The Commission has issued the enclosed Amendment No. 13 to Facility License No. DPR-23 for the H. B. Robinson Unit 2 facility. This amendment includes Change No. 38 to the Technical Specifications, and is in response to your request dated October 2, 1974 as supplemented March 14, 1975, April 18, 1975, June 20, 1975, and July 24, 1975.

H. B. ROBINSON UNIT 2

Amendment No. 13
License No. DPR-23

ATTACHMENT TO LICENSE AMENDMENT NO. 13
CHANGE NO. 38 TO THE TECHNICAL SPECIFICATIONS
FACILITY OPERATING LICENSE NO. DPR-23
DOCKET NO. 50-261

FIGURE 3.10-1

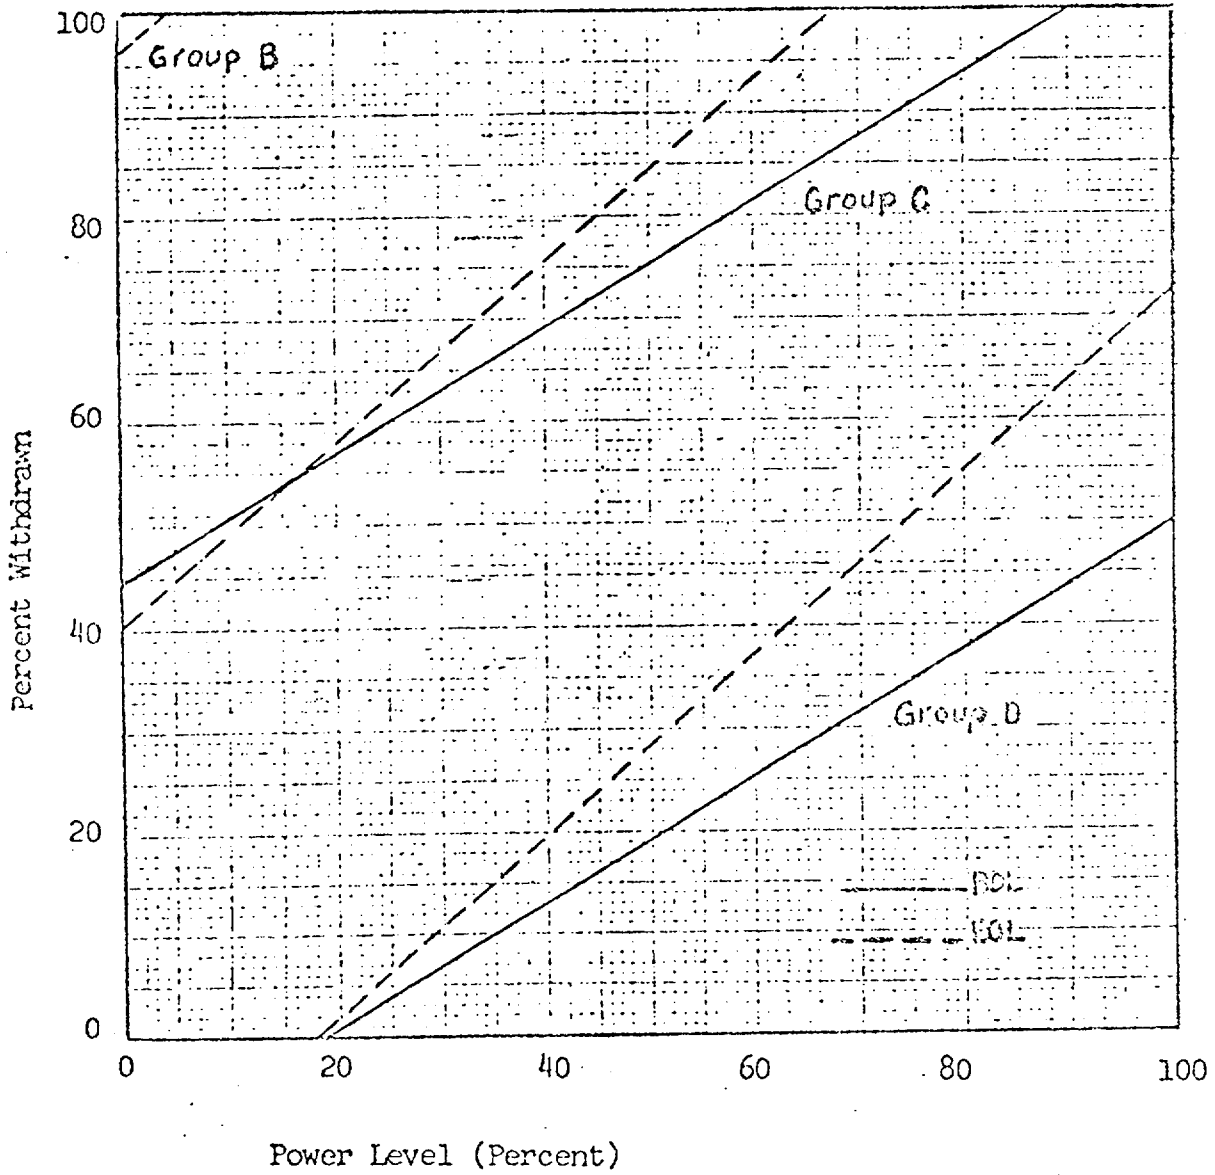
3.10.1.3 When the reactor is critical, except for physics tests and full length control rod exercises, the control rods shall be no further inserted than the limits shown by the solid lines on Figure 3.10-1 for 3 loop operation.

3.10.1.4 After 50% of the second and subsequent cycles as defined by burnup, the limits shall be adjusted as a linear function of burnup toward the end-of-core life values as shown by the dotted lines on Figure 3.10-1.

Figure 3.10-2

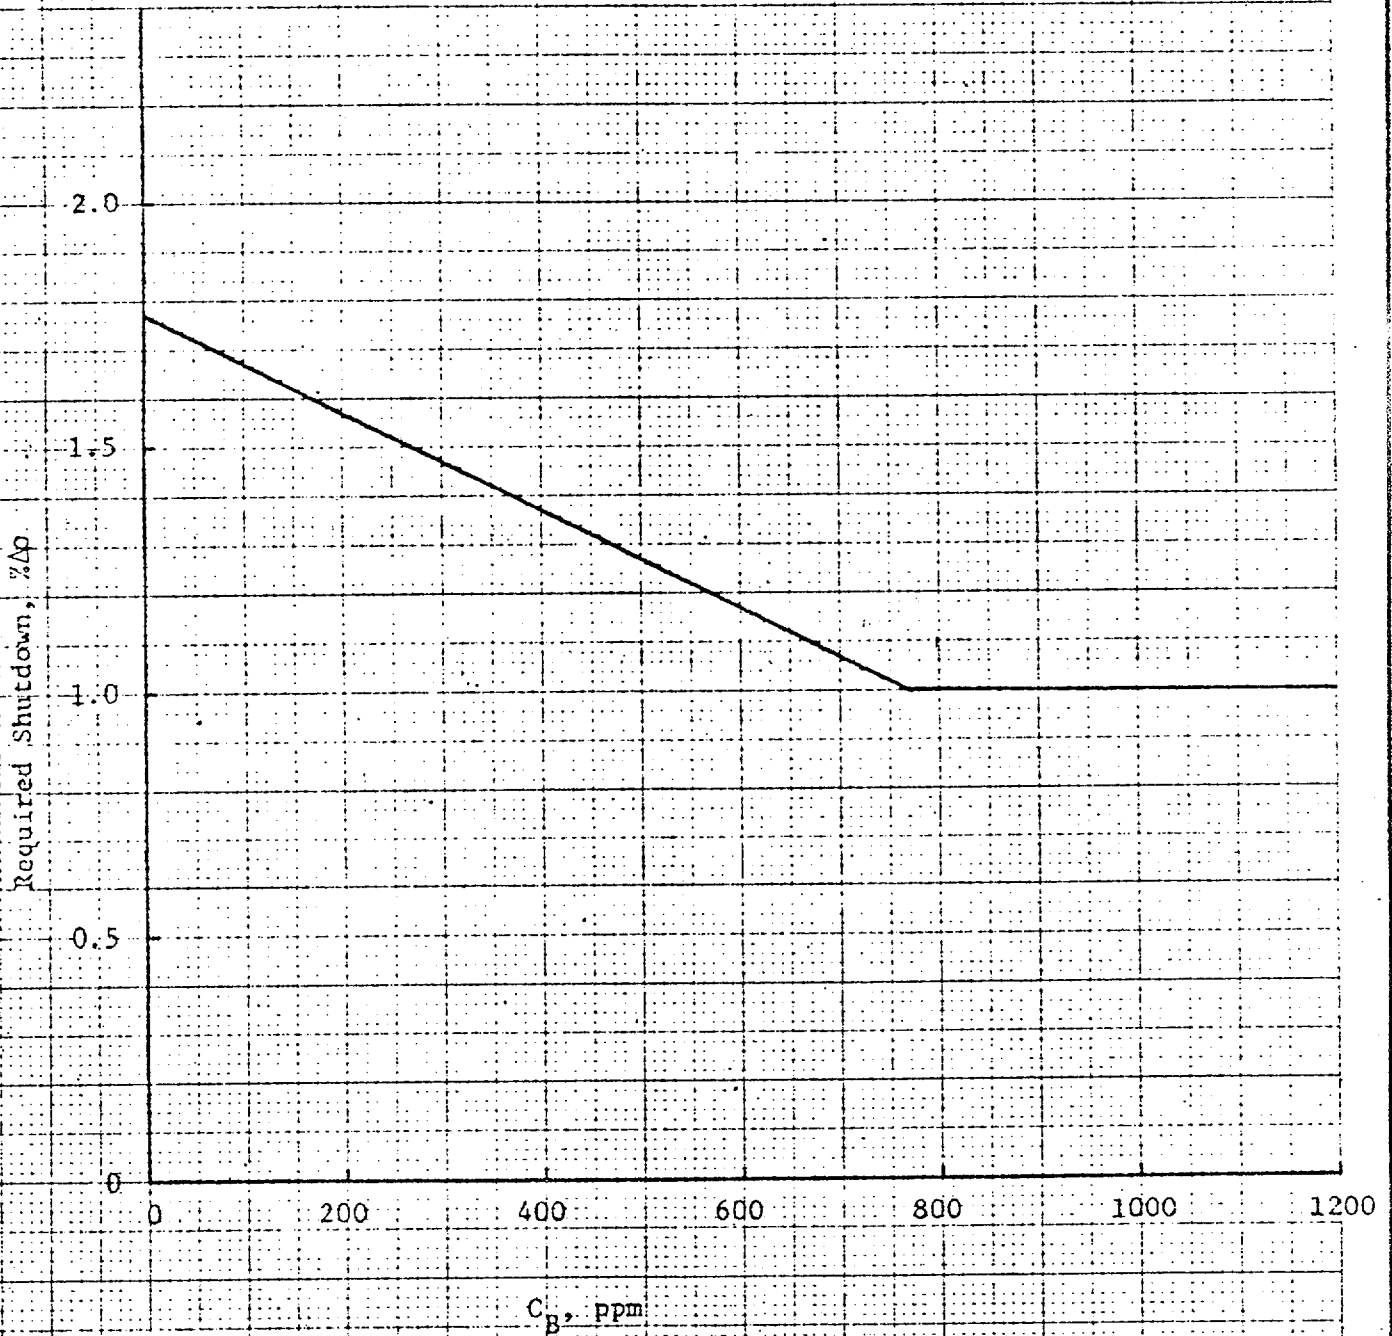
3.10.1.6 Insertion limits do not apply during physics tests or during periodic exercise of individual rods. However, the shutdown margin indicated in Figure 3.10-2 must be maintained except for the low power physics test to measure control rod worth and shutdown margin. For this test the reactor may be critical with all but one full length control rod inserted and part length rods fully withdrawn.

- 3.10.8.1 When the reactor is in the hot shutdown condition, the shutdown margin shall be at least that shown in Figure 3.10-2.
- 3.10.8.2 When the reactor is in the cold shutdown condition, the shutdown margin shall be at least 1% $\Delta k/k$.
- 3.10.8.3 When the reactor is in the refueling operation mode, the shutdown margin shall be at least 10% $\Delta k/k$.

Figure 3.10-3 Normalized Axial Dependence Factor for F_Q versus Elevation

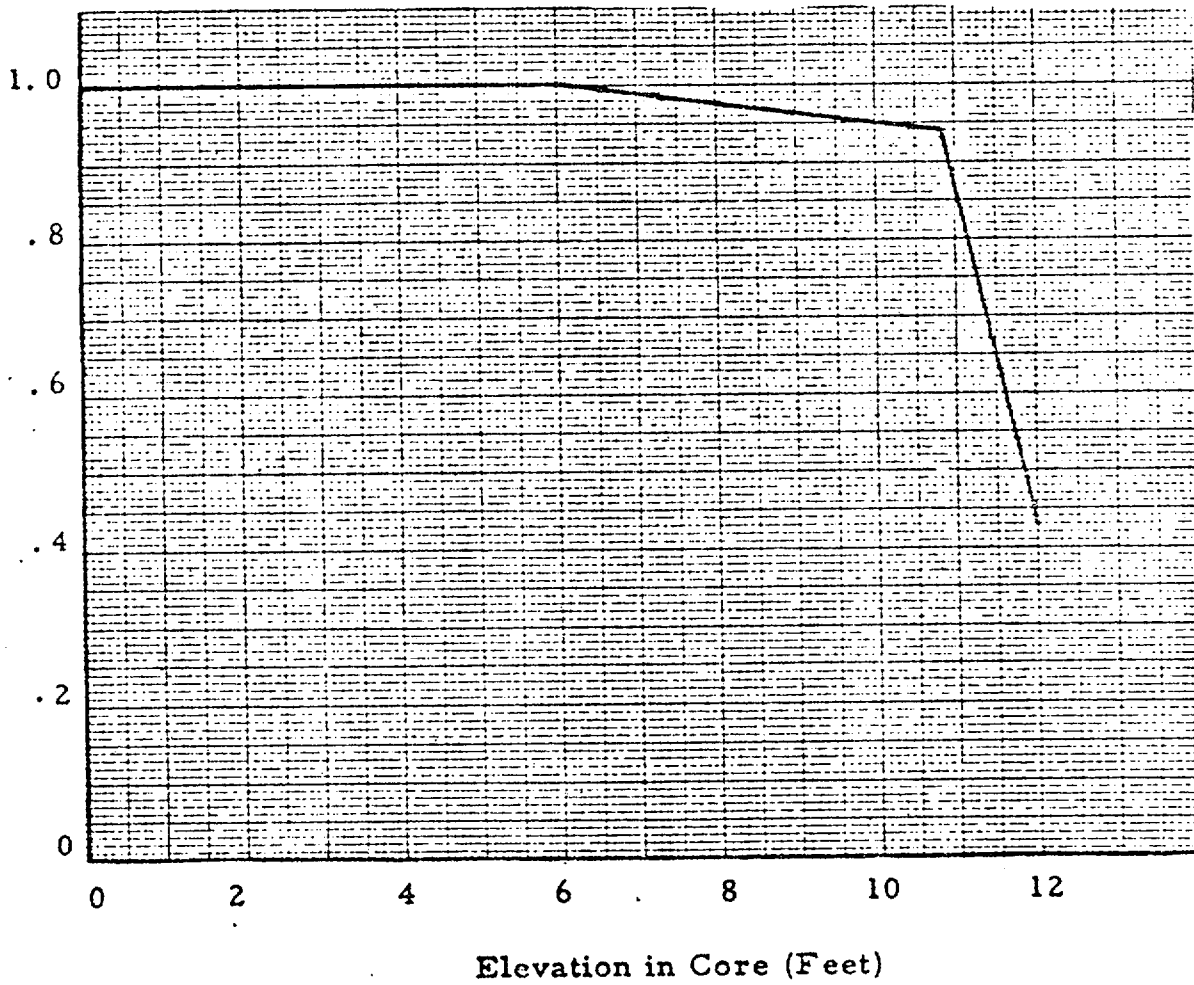
$$F_Q(Z) \leq (2.30/P) \times K(Z) \text{ for } P > .5$$

where P is the fraction of rated power at which the core is operating, K(Z) is the function given in Figure 3.10-3, and Z is the core height location of F_Q .

$K(z)$ is the normalized peaking factor axial dependence used in the LOCA analysis and is shown in Figure 3.10-3. For normal operation, it is not necessary to measure these quantities. Instead, it has been determined that, provided certain conditions are observed, the above hot channel factor limits will be met; these conditions are as follows:
